SARA reference: 2404-40203 SRA
Council reference: OTH/2024/20

SARA response – 10 Homestead Drive, Stapylton

Description:	Request for a change application, other than a minor change, to a development approval pursuant to section 82 of the *Planning Act 2016*, to Development Permit for a Material change of use for Warehouse and Development Permit for Operational work for Change to ground level.
SARA role:	Referral Agency
SARA trigger:	Schedule 10, Part 7, Division 3, Table 1, Item 1 – Material change of use for a hazardous chemical facility (Planning Regulation 2017)
SARA reference:	2404-40203 SRA
Assessment Manager:	Gold Coast City Council
Street address:	10 Homestead Drive, Stapylton
Real property description:	Lot 122 on SP329476
Applicant name:	FPI Queensland Pty Ltd

SK-01 Rev.2
Proposed Dangerous Goods Strategy
19/06/2024

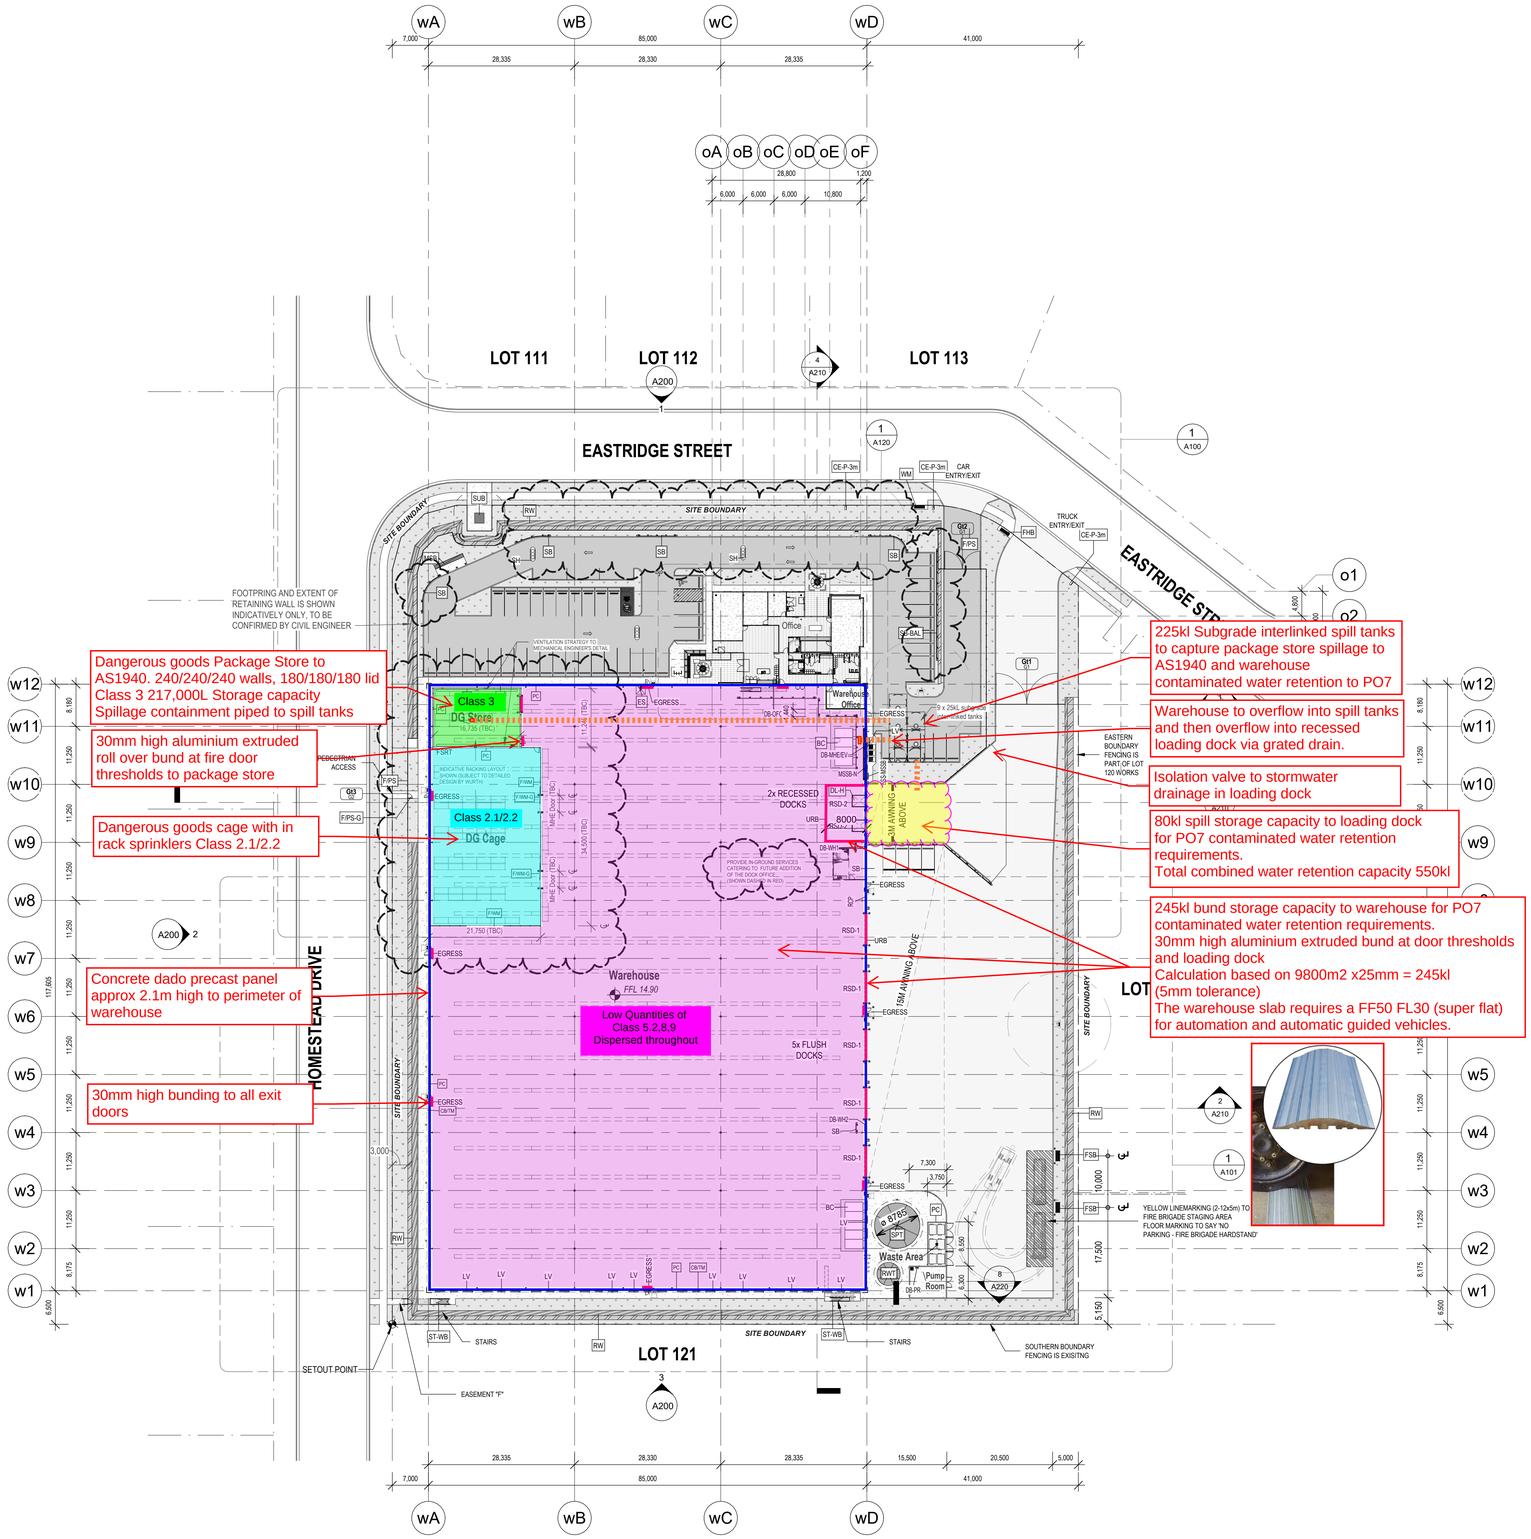
2.	The spillage capacity must be in accordance with the Proposed Dangerous Goods Strategy, prepared by HL Architects Pty Ltd, dated 19/06/2024, reference no. SK-01 and revision 2.	Prior to the commencement of use and to be maintained at all times.
